P&Z CASE # MIS2022-019 P&Z DATE 08/30/2022 CC DATE _____ Approved/Denied

**Rockwall ISD – Updated Site Plans for Ninth Grade Center Projects:
SP 2022-17 (FM1141& Quail Run) & SP2022-18 (John King Blvd at GBCCA)**

PLANNING AND ZONING COMMISSION MEMORANDUM

DEPARTMENT	REVIEWER	DATE OF REVIEW	STATUS OF PROJECT
PLANNING	Bethany Ross	08/26/2022	Approved w/ Comments

LANDSCAPE PLAN
AREA B

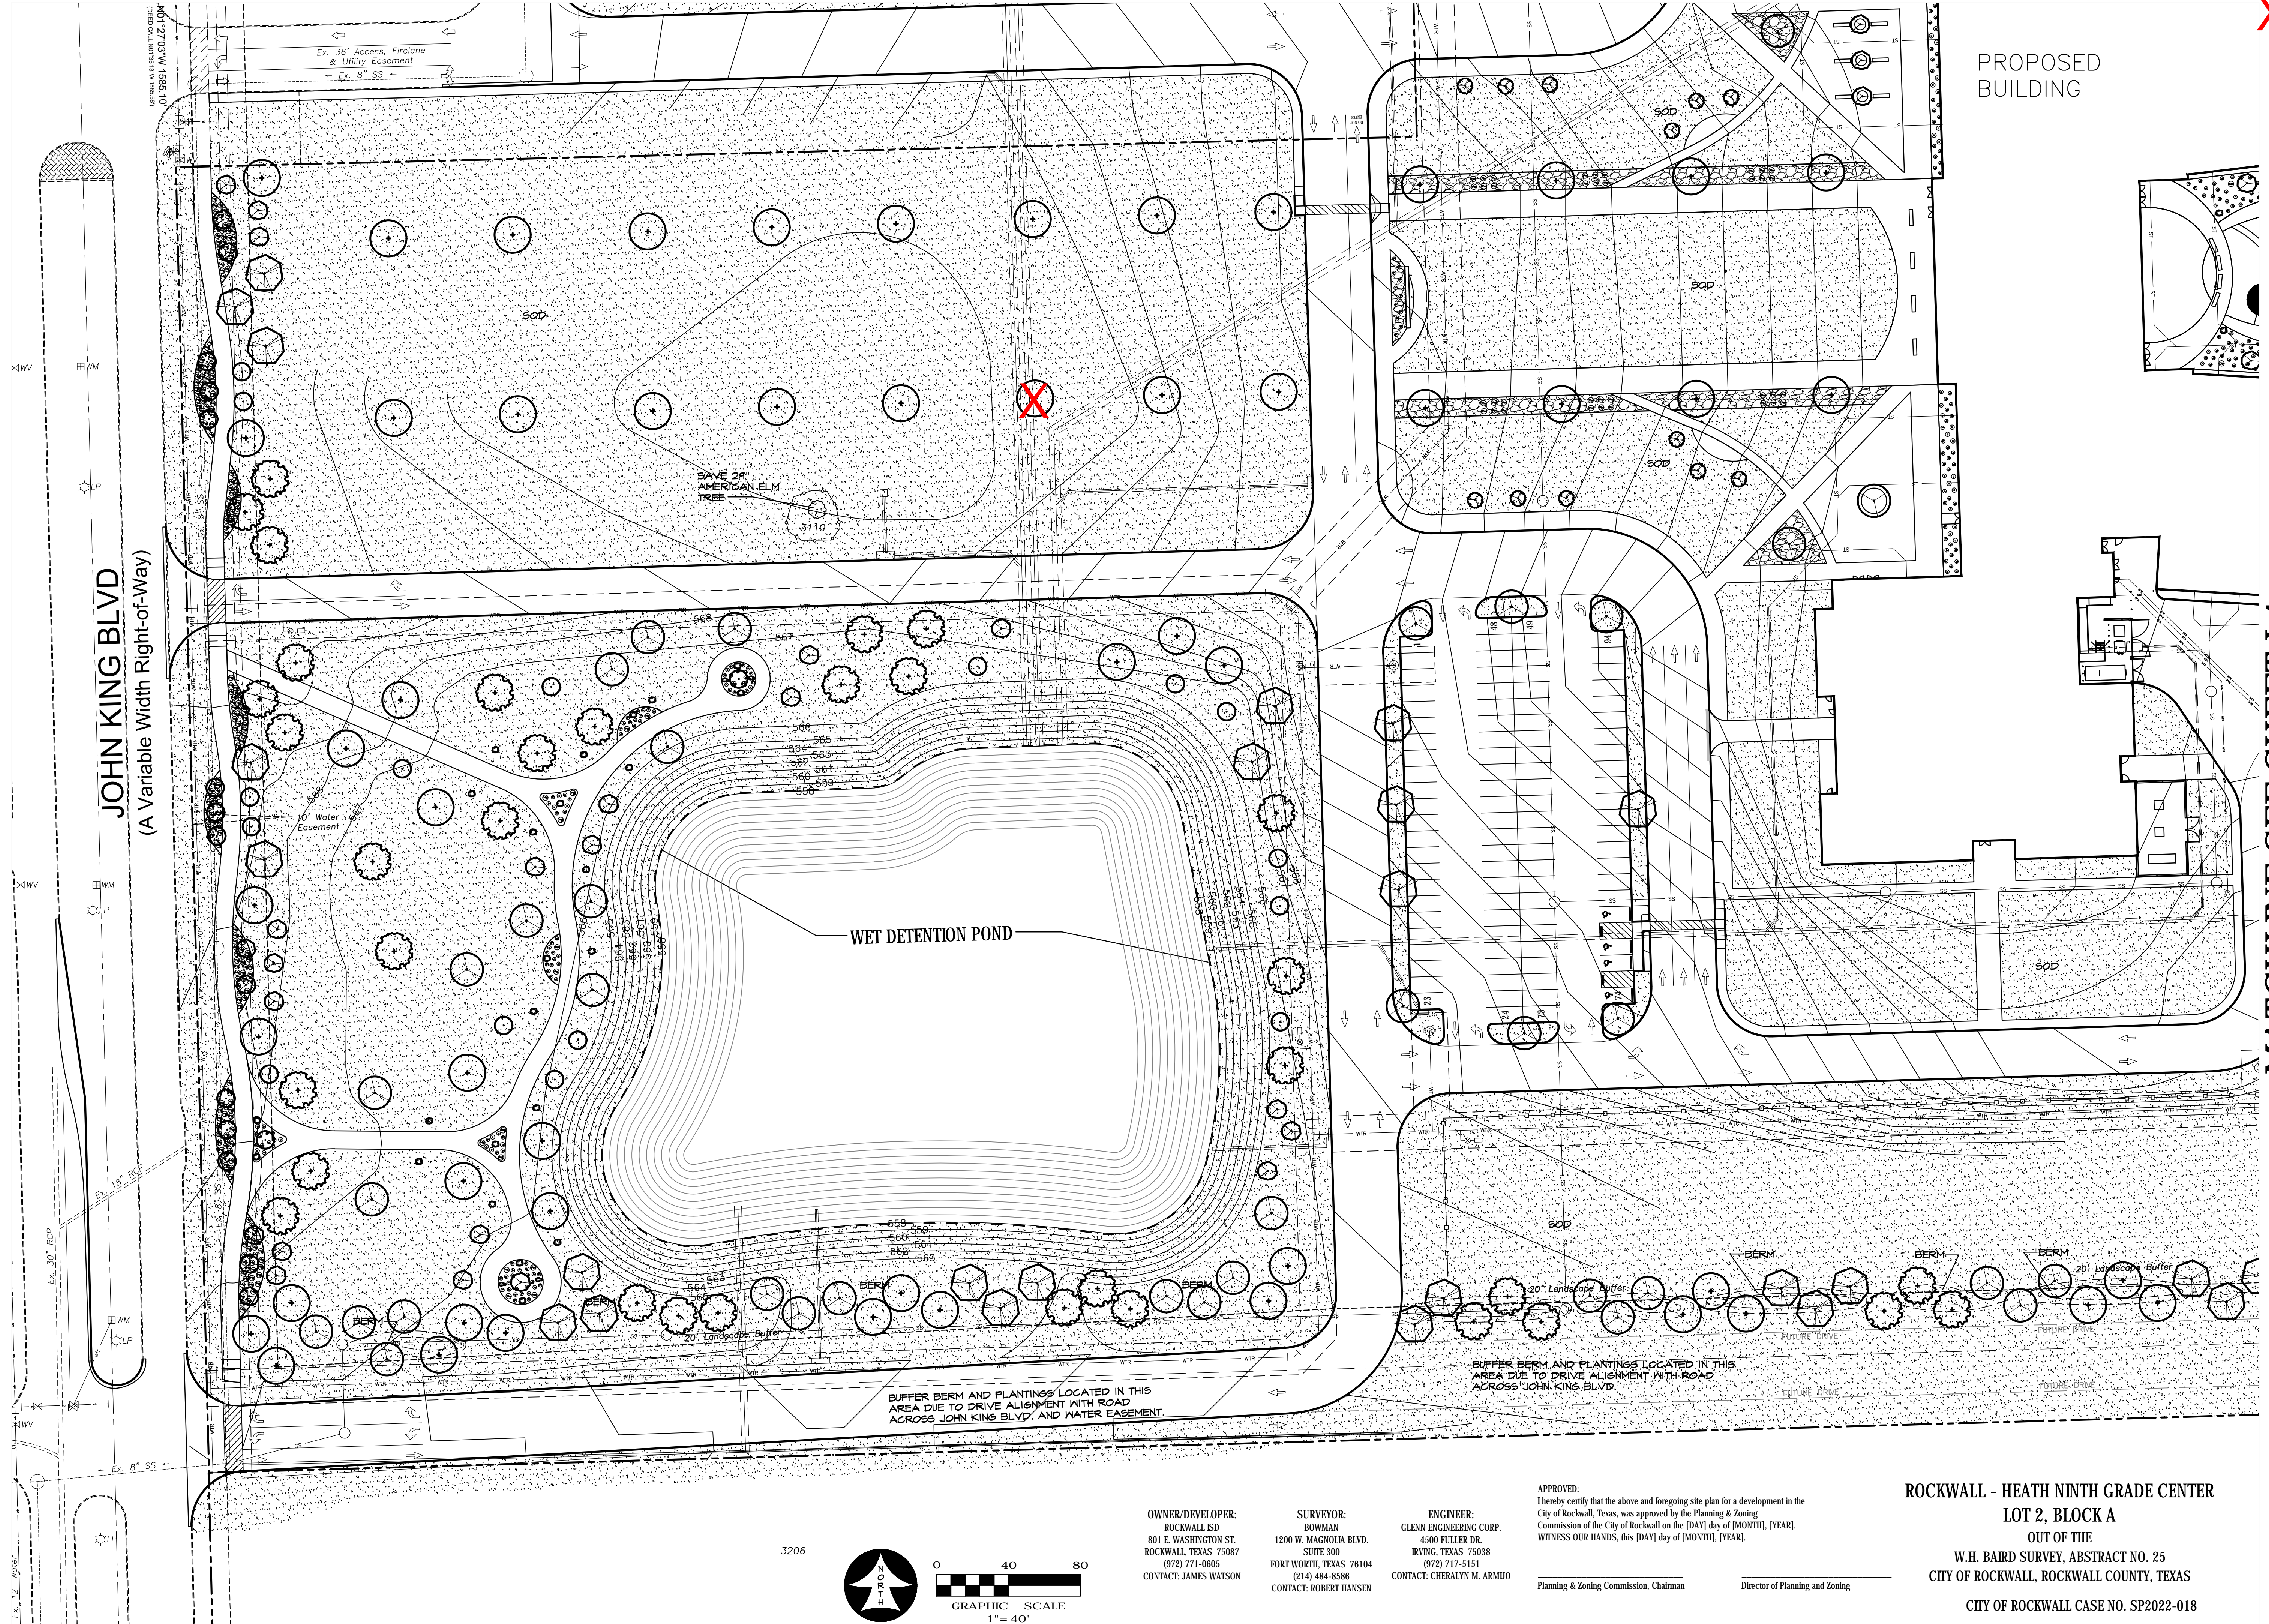
- (1) To omit 35% of the required trees for the detention area and disperse the remaining 65% throughout the site. The applicant has provided an alternate Landscape Plan that represents this request,
- (2) An exception to the maximum allowed foot candles within the sports fields proposed on the site. The maximum proposed illumination level represented in the provided photometric plan is 70 FC, and
- (3) An exception to the maximum light pole height within the sports fields proposed on the site. The maximum proposed light pole height represented in the provided photometric plan is 80 feet.

BUFFER BERM AND PLANTINGS LOCATED IN THIS AREA DUE TO DRIVE ALIGNMENT WITH ROAD ACROSS JOHN KING BLVD. AND WATER EASEMENT.

BUFFER BERM AND PLANTINGS LOCATED IN THIS AREA DUE TO DRIVE ALIGNMENT WITH ROAD ACROSS JOHN KING BLVD.
